RHODE ISLAND DEPARTMENT OF TRANSPORTATION

RHODE ISLAND CONTRACT NO.2013-CT-105

Traffic Safety Improvements to Plainfield Pike at Interstate I-295 (HSIP Funds)

ADDENDUM NO. 1 Prospective bidders and all concerned are hereby notified of the following changes in the Plans, Specifications, Proposal and Distribution of Quantities for this contract. These changes shall be incorporated in the Plans, Specifications, Proposal and Distribution of Quantities, and shall become an integral part of the Contract Documents.

TYPICAL ROADWAY SECTION

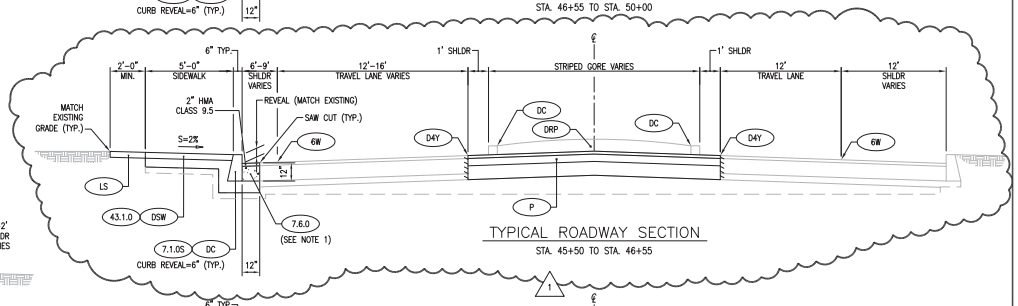
Delete Sheet 6 of 35 - Typical Sections in its entirety and replace with Sheet 6 of 35 - Typical Sections (R-1). A typical section has been added from Station 45+50 to Station 46+55 to represent the area of median removal and full depth pavement construction. The callout for 6Y has been modified to 6W for the typical section from STA. 28+50 to STA. 31+25 and from STA. 38+85 to STA. 41+00. The 6Y callout was labeled incorrectly. The scale under the title block has been modified from "N/A" to "N.T.S."

GENERAL PLAN No. 4

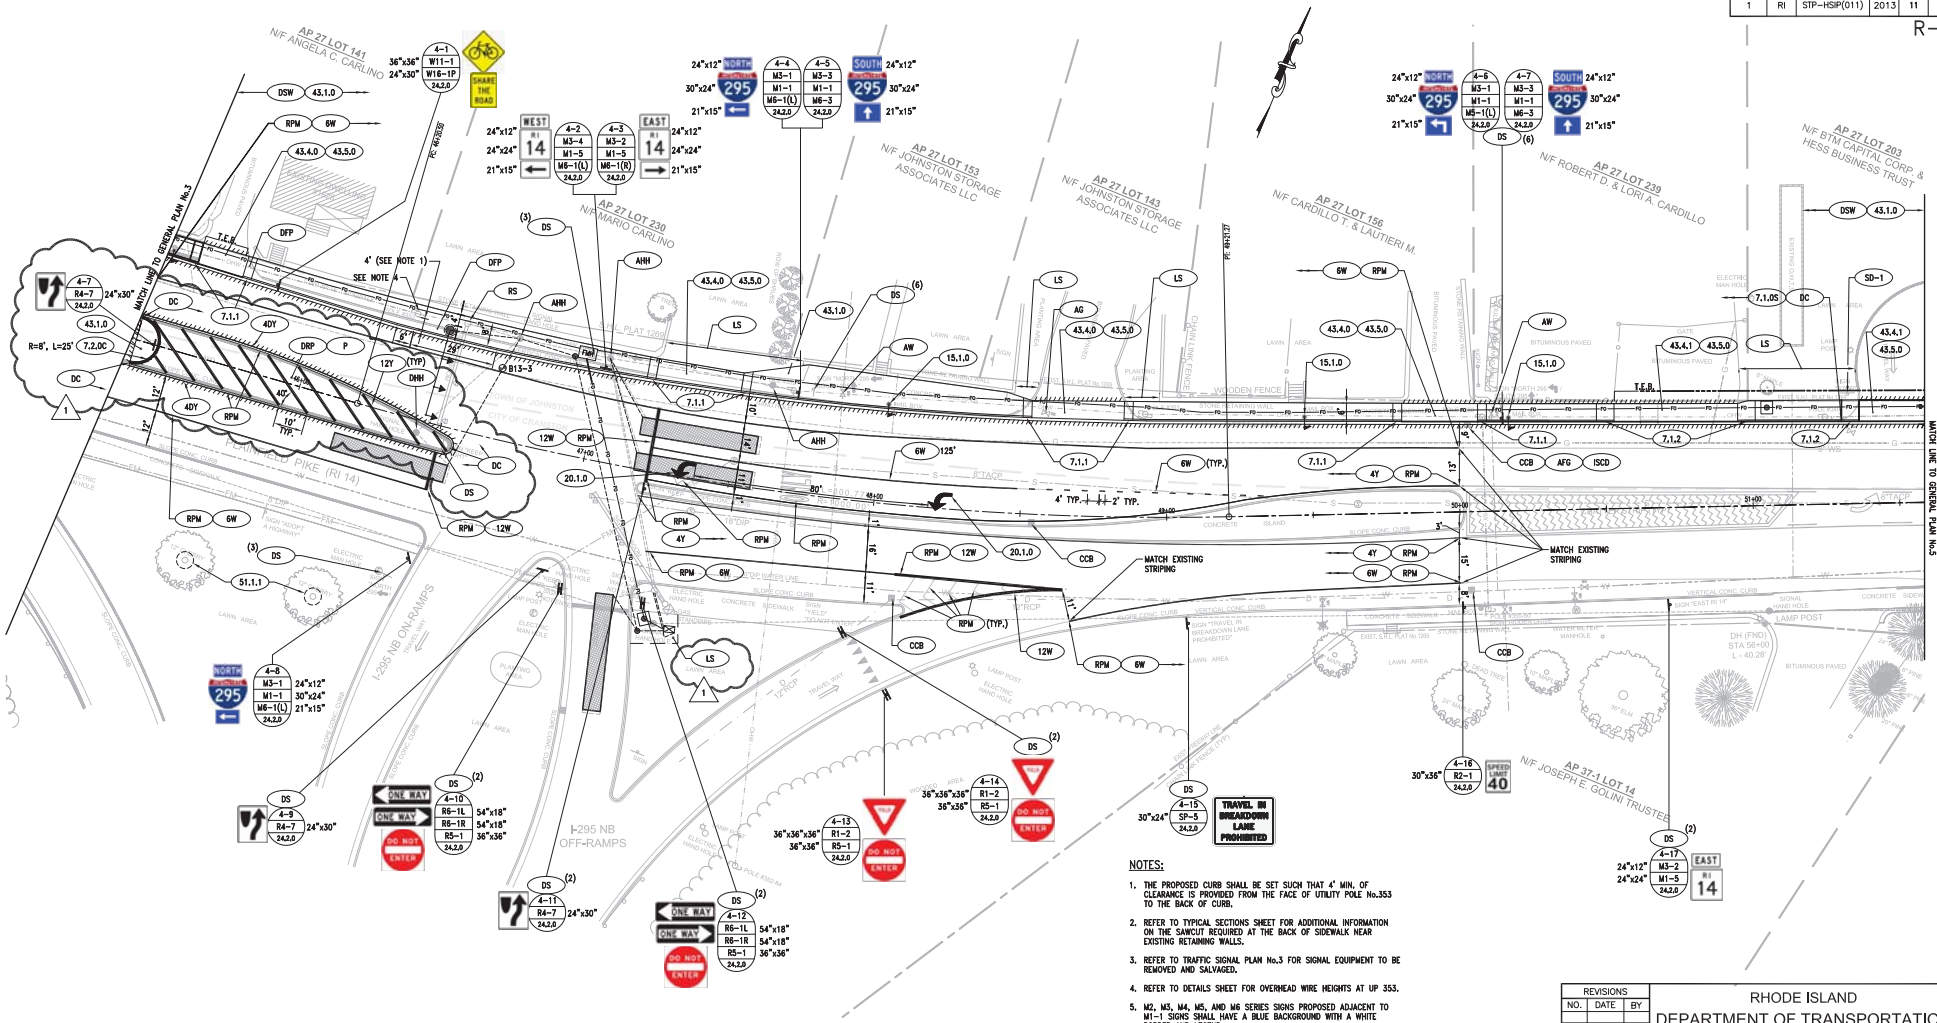
Delete Sheet 11 of 35 - General Plan No. 4 in its entirety and replace with Sheet 11 of 35 - General Plan No. 4 (R-1). The concrete median on Plainfield Pike just west of the Plainfield Pike/I-295 NB Ramps intersection is to be removed and replaced with full depth pavement reconstruction and gore striping. The existing signal handhole located within the median shall be removed and disposed. 4" Loam and Seed, LS, has been added to the southeast corner of the intersection.

LOCATION PLAN No. 4
STA. 45+42 TO STA. 51+58

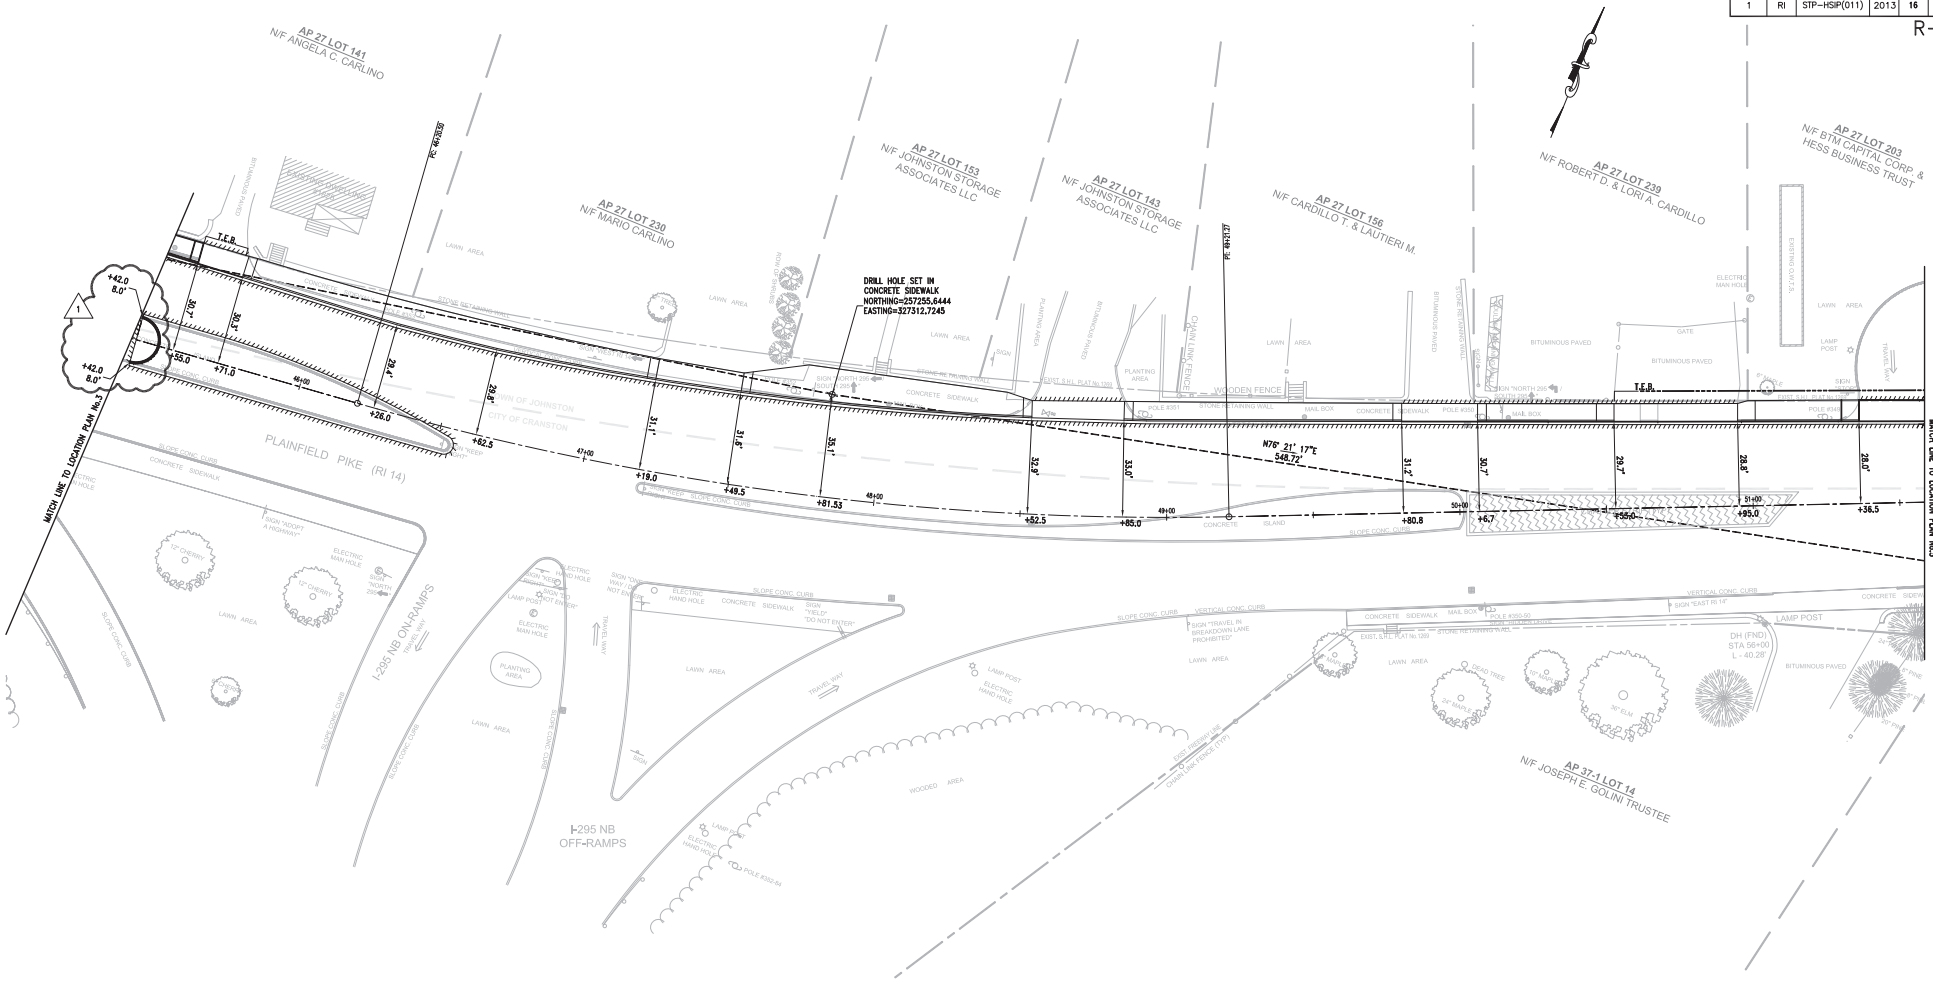
Delete Sheet 16 of 35 - Location Plan No. 4 in its entirety and replace with Sheet 16 of 35 - Location Plan No. 4 (R-1). The limits of the modified concrete median curbing have been added to the plan.

TRAFFIC SIGNAL PLAN No. 3

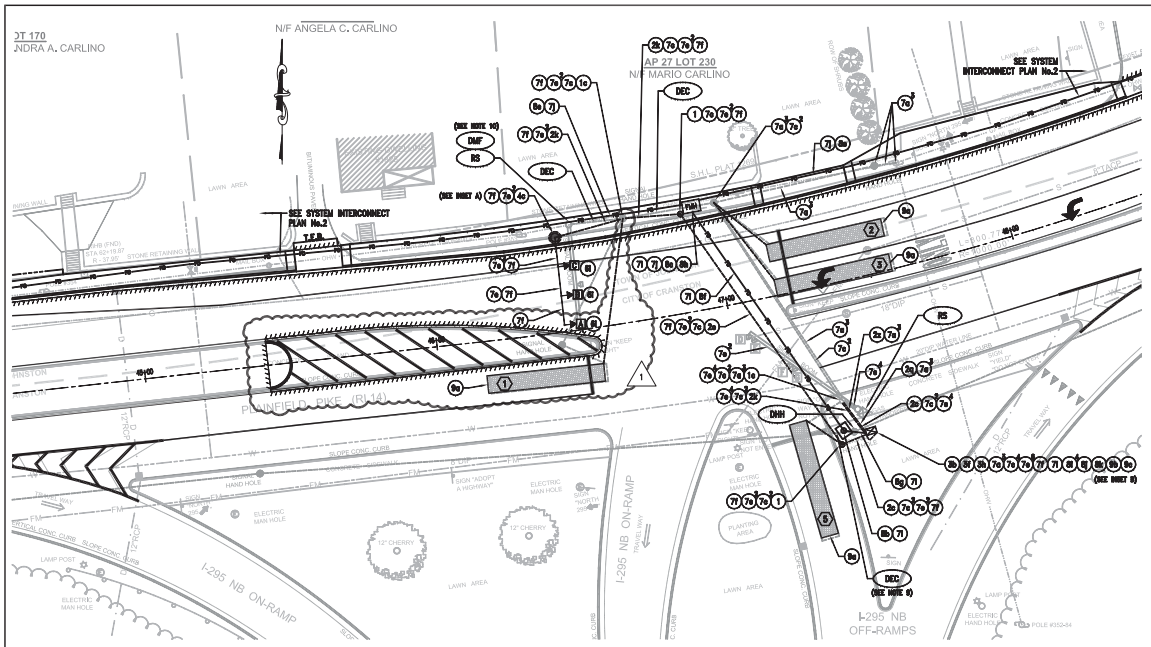
Delete Sheet 20 of 35 - Traffic Signal Plan No. 3 in its entirety and replace with Sheet 20 of 35 - Traffic Signal Plan No. 3 (R-1). The leader for the 6'x40' loop detector in the eastbound approach on Plainfield Pike has been modified to connect into the signal handhole on the north side of the intersection as shown on the Plan. The revised limits of the concrete median are also shown on the Plan.
